**NOTICE OF PREPARATION OF A
DRAFT ENVIRONMENTAL IMPACT REPORT FOR THE
NATIONAL CITY CARMAX AND HOTEL PROJECT**

Project Title: National City CarMax and Hotel Project

Caltrans has reviewed the Notice of Preparation (NOP) for the draft Environmental Impact Report (EIR) on the proposed CarMax and Hotel Project which is adjacent to State Route 54 (SR-54) and Plaza Bonita Road in National City. Caltrans has the following comments:

Subject: Comments on the Notice of Preparation of a Draft Environmental Impact Report for the National City CarMax and Hotel Project SCH# 2016111035

National City Car-Max and Hotel Project Existing Easement and Water Facilities

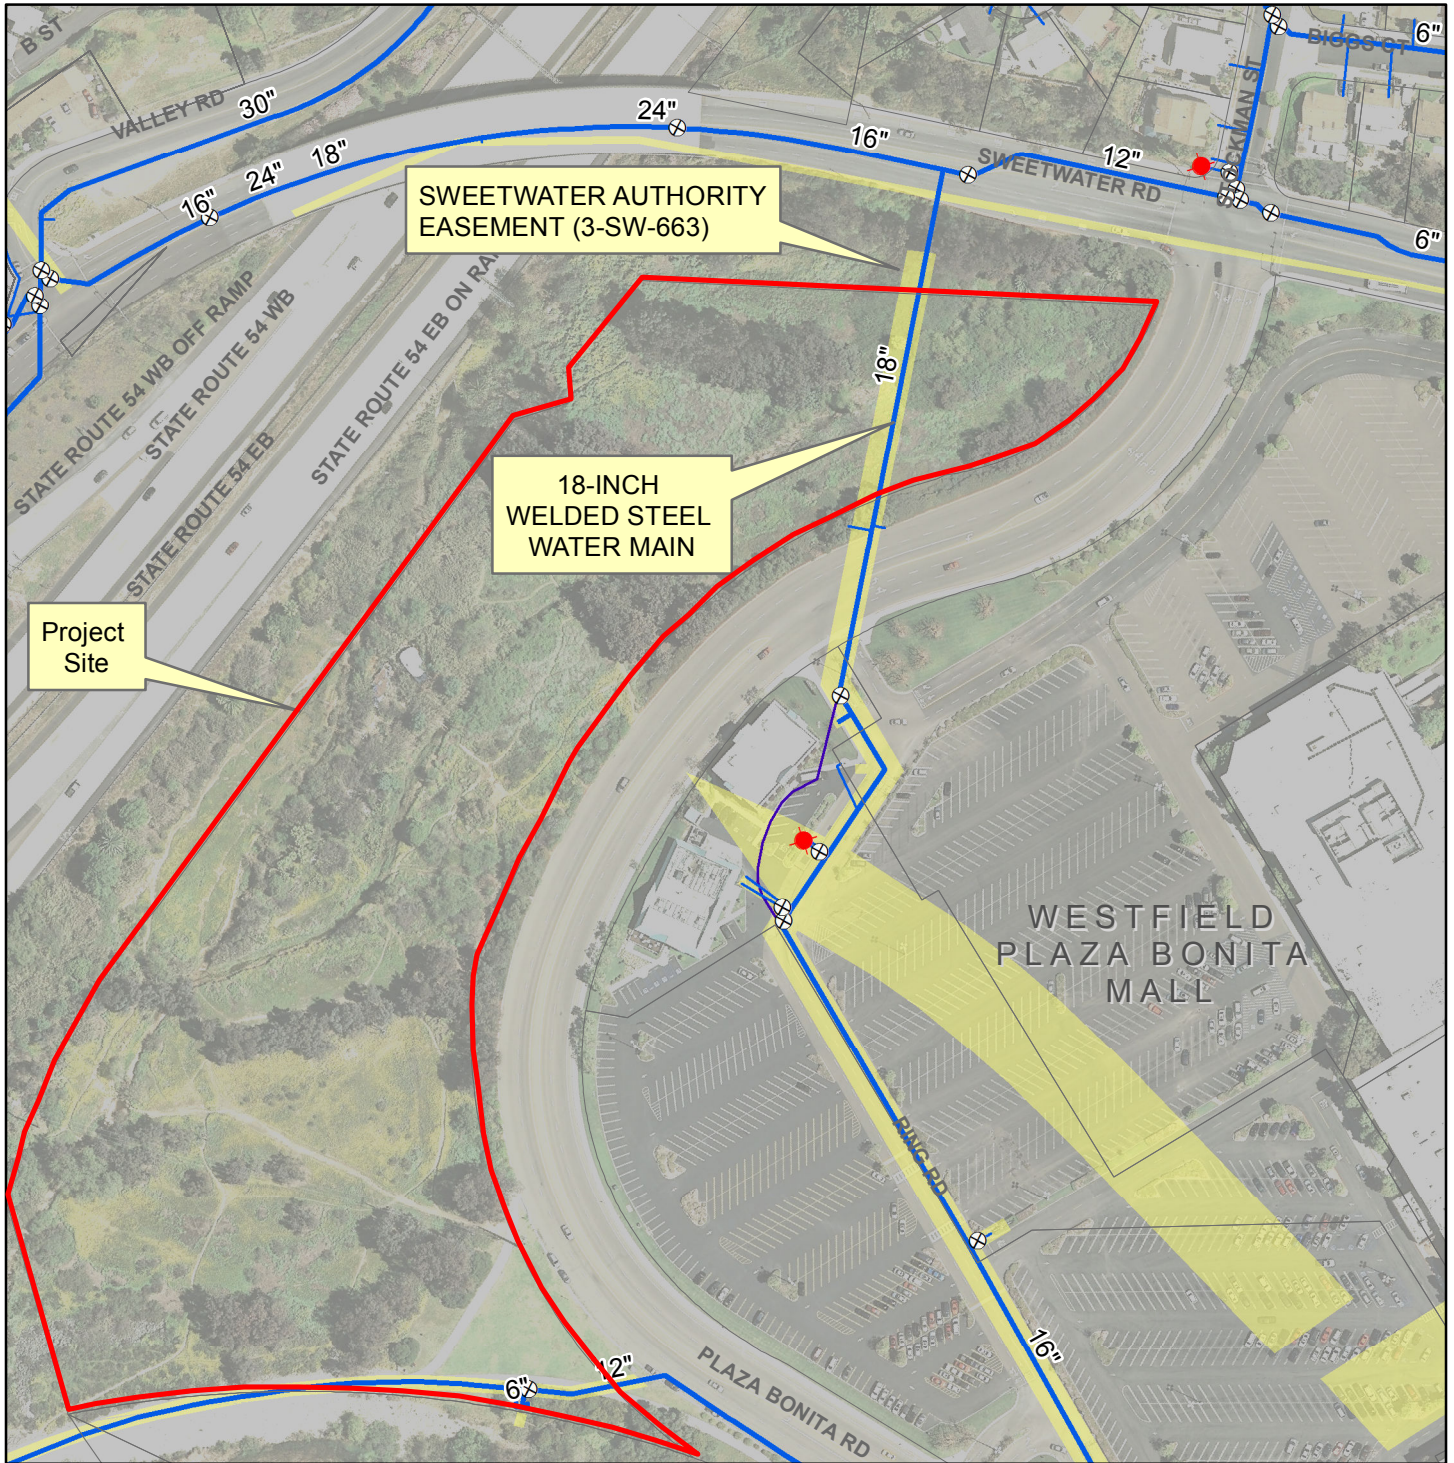
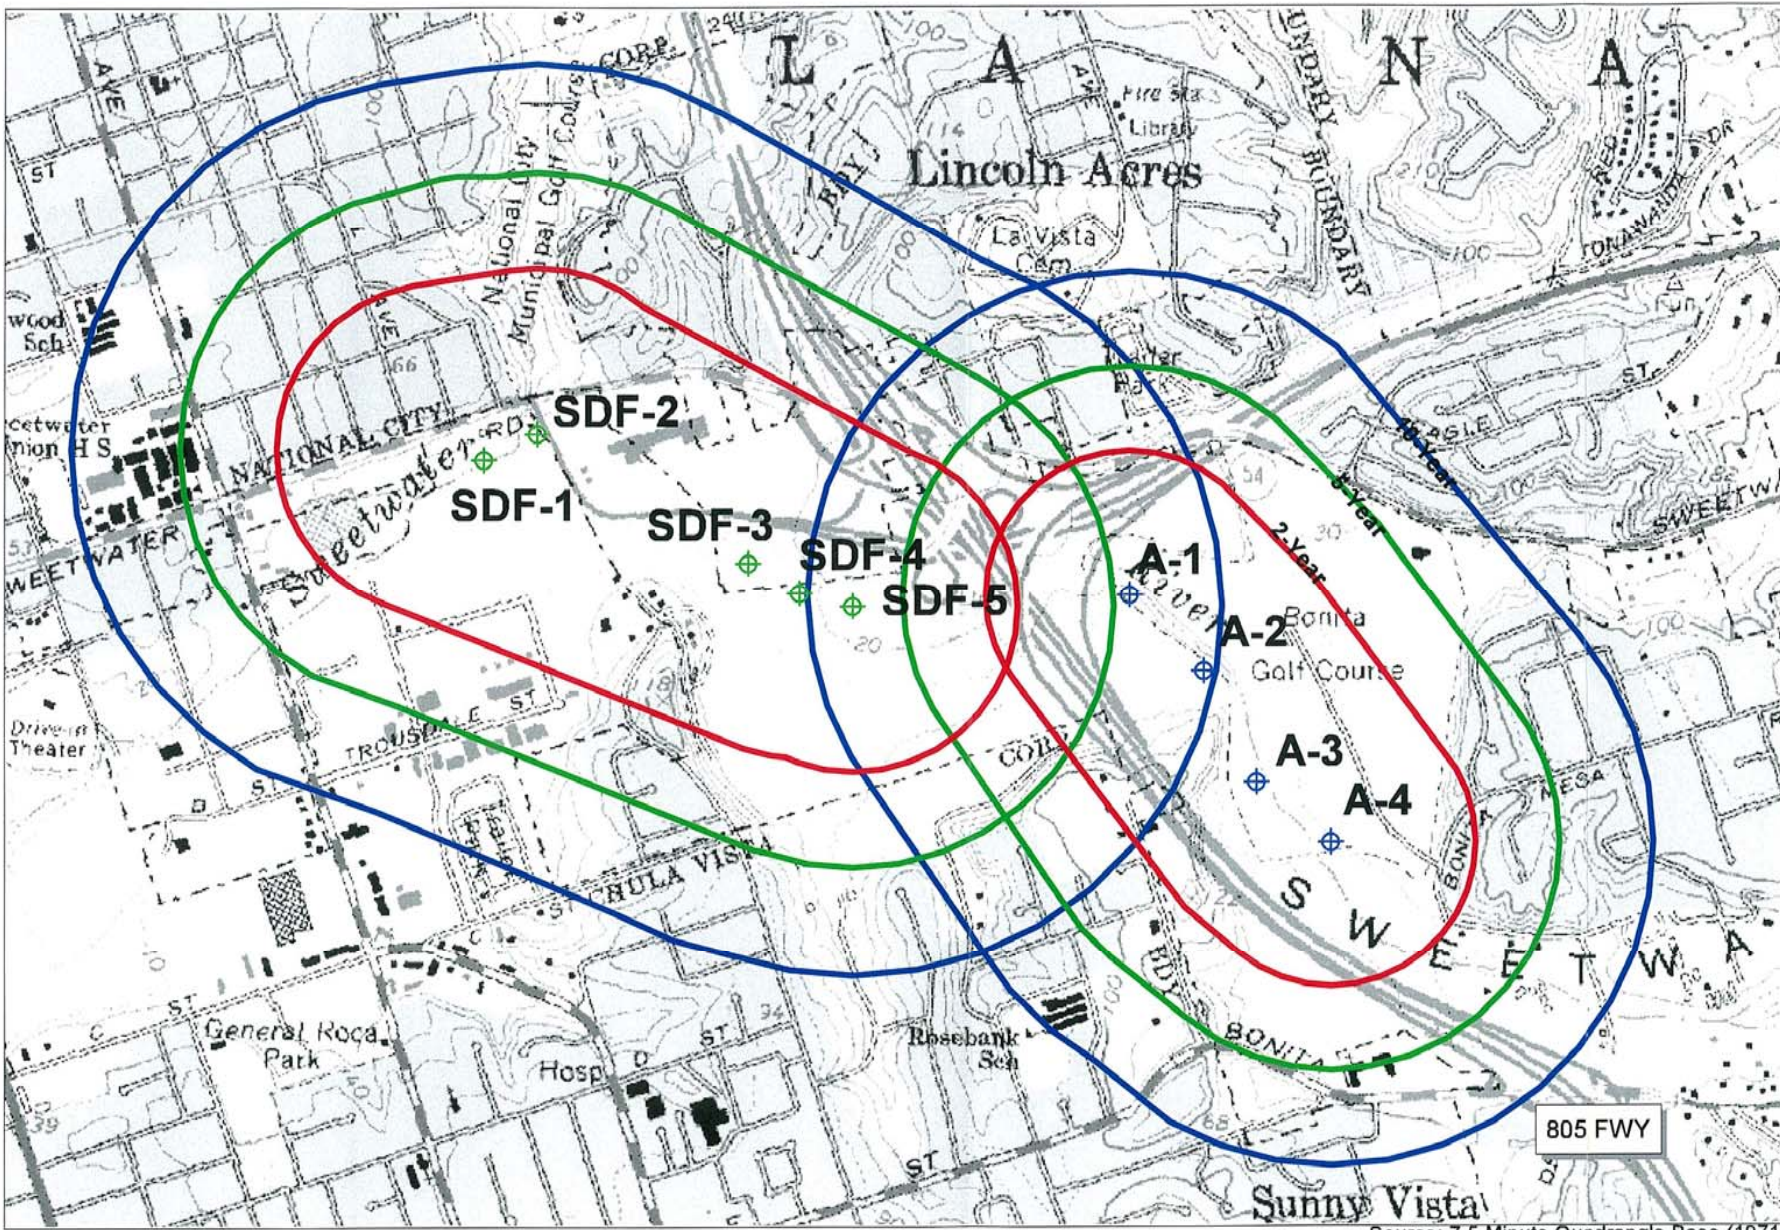
Sweetwater Authority (Authority) has received a Notice of Preparation (NOP) of a Draft Environmental Impact Report (DEIR) for the above-referenced project, within the City of National City. It is understood that the project is on a 15.08 acre site near the southeast corner of the Interstate 805 and State Route 54 interchange, and will involve the construction of an automobile dealership, grading to accommodate a potential future hotel, and re-contouring of the unnamed tributary over the subject parcel. It is further understood that the project will require General Plan, Zoning, and Land Use Code amendments to allow for the proposed uses. It is to be noted that the Authority owns and operates an 18-inch welded steel water transmission main located within a 30-foot wide easement over the subject parcel, as shown on the enclosed Exhibit A.
